Intersection ID: 44264	Main Street: ISAAC_HUNTER_DR	Cross Street: LAWING_SCHOOL_RD	Location:	N
ADA ID: 6B19CD022C97	Ramp Type: Perp	Initial Pass/Fail: Fail	Overall Compliance: No	Severity Score: 21.25

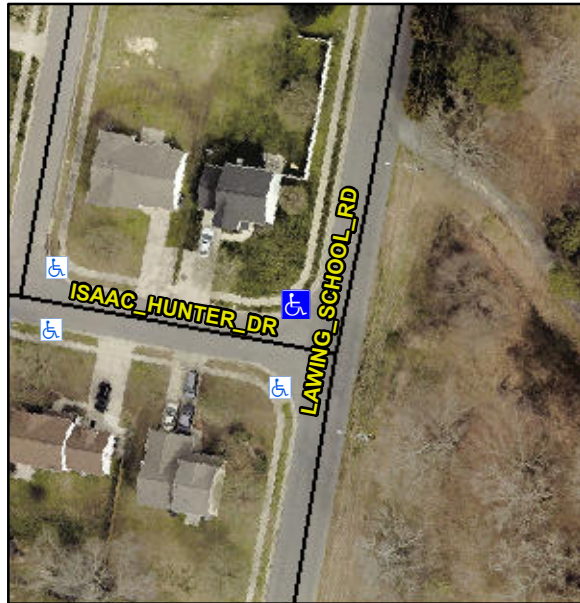
Not Found, R304.5.1, R304.2.2

Compliance	Description	Data	Compliance	Description	Data
N/A	Ramp Length (in)	43.0	No	Ramp Slope (%)	11.9
No	Ramp Width (in)	38.0	Yes	Ramp XSlope (%)	0.4
N/A	Flare Type LT	N/A	N/A	Flare Type RT	N/A
N/A	Flare Slope LT (%)	N/A	N/A	Flare Slope RT (%)	N/A
N/A	Flare Traversable LT?	N/A	N/A	Flare Traversable RT?	N/A
N/A	Landing Length (in)	N/A	N/A	DWS Provided?	N/A
N/A	Landing Width (in)	N/A	N/A	DWS Contrast?	N/A
N/A	Landing Slope (%)	N/A	N/A	DWS Length (in)	N/A
N/A	Landing X Slope (%)	N/A	N/A	DWS Full Width?	N/A
N/A	Landing Curb? (Y/N)	N/A	N/A	DWS Offset (in)	N/A
N/A	Shared Landing?	N/A			
N/A	Gutter Ponding?	N/A	N/A	Gutter Slope (%)	N/A
N/A	Gutter Lip Ht (in)	N/A	N/A	Gutter X Slope (%)	N/A
N/A	Painted X Walk1?	No	N/A	Painted X Walk2?	N/A
	X Walk 1 Direction	To SW		X Walk 2 Direction	N/A
N/A	X Walk 1 Width (in)	N/A	N/A	X Walk 2 Width (in)	N/A
	X Walk 1 Slope (%)	2.4		X Walk 2 Slope (%)	N/A
	X Walk 1 X Slope (%)	2.5		X Walk 2 X Slope (%)	N/A

Remove & Replace Entire Ramp.
